PLANNING AND ZONING BOARD

Being held at Thursday, April 18, 2019
Jarvis Hall 4505 N. Ocean Drive 33308

- 5.b 2019-SP-01 Site Plan Review – 4433 Poinciana Street (Bonnan by the Sea)

To: Planning and Zoning Board
From: Linda Connors, Development Services Director
Date: March 26, 2019
Meeting Date: April 17, 2019
Project: 2019-SP-01 Site Plan Review – 4433 Poinciana Street (Bonnan by the Sea)

Precast Concrete Fence - West Elevation
FACING RD-10 ZONING DISTRICT

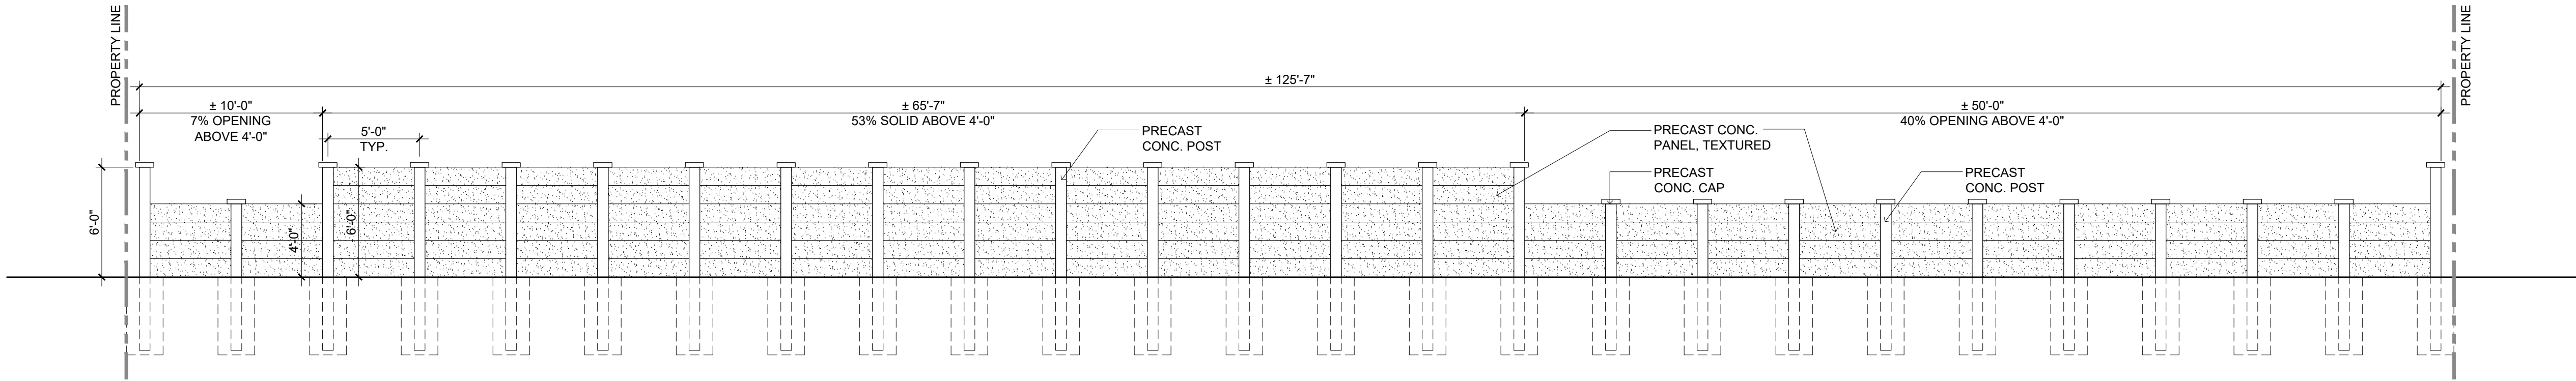
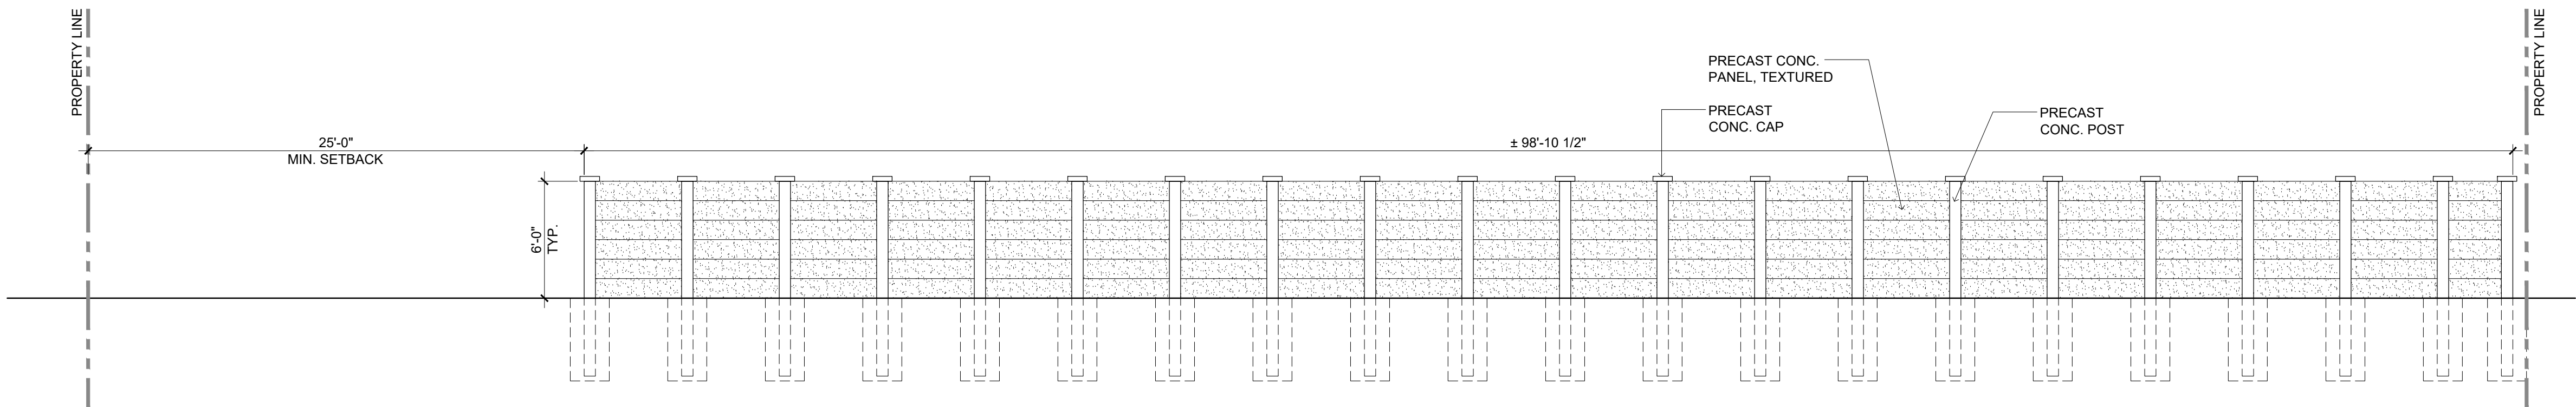
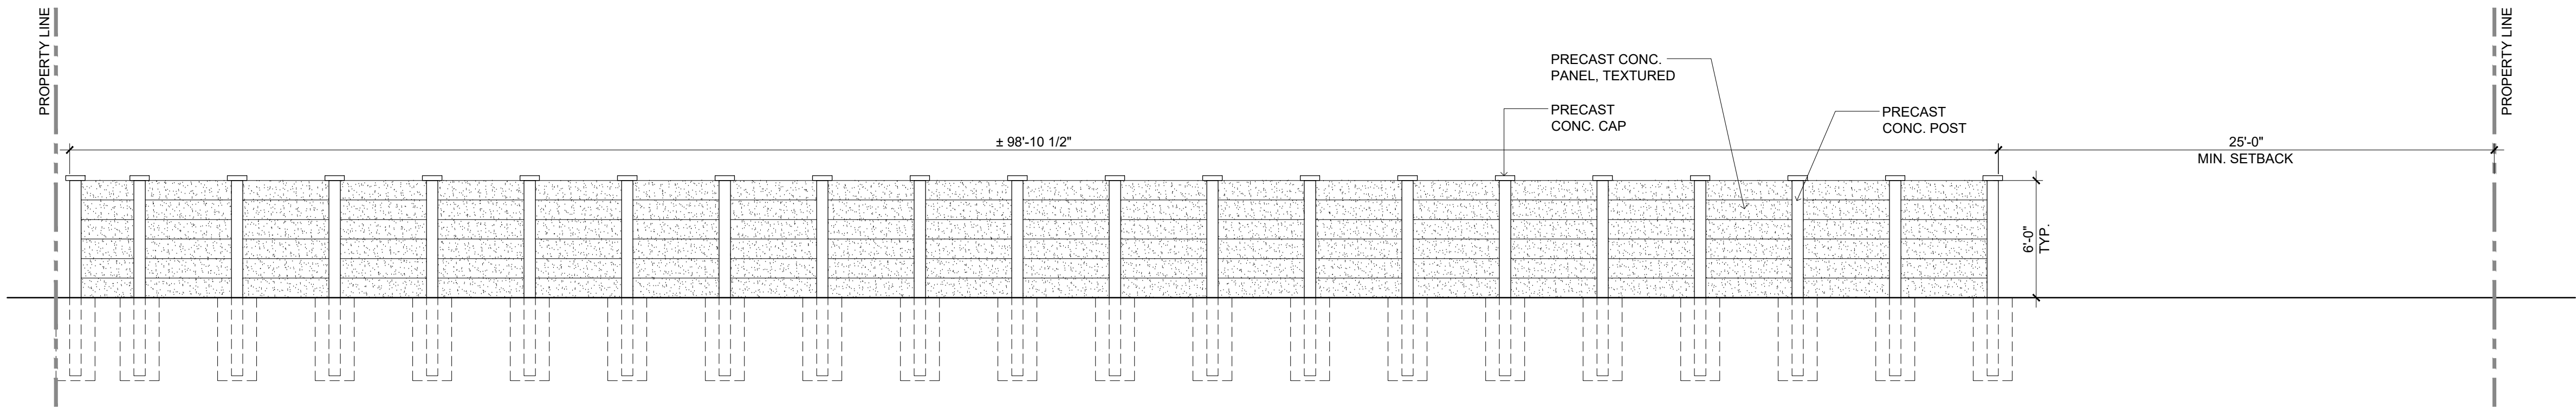
While the building meets the requirements of the design guidelines, the proposed wall surrounding the property does not. Staff is proposing that the Site Plan be approved prior to the final design of the wall. A condition that the proposed wall comply with the architectural guidelines will be added to the development order.
